INFO-TECH CITROËN Racing C2 R2 MAX N° 14/09.

Subject : Engine fan bracket, Length screw reduction.

I -Risk location :

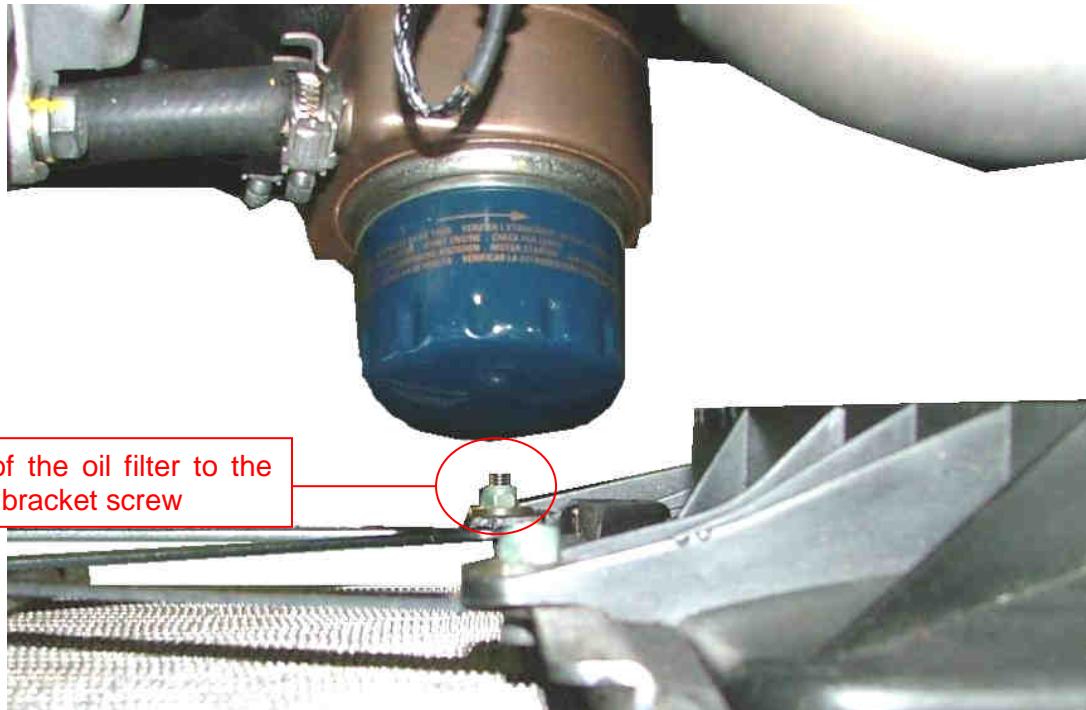
In case of a front crash, a screw of the engine fan bracket may damage the engine oil filter.
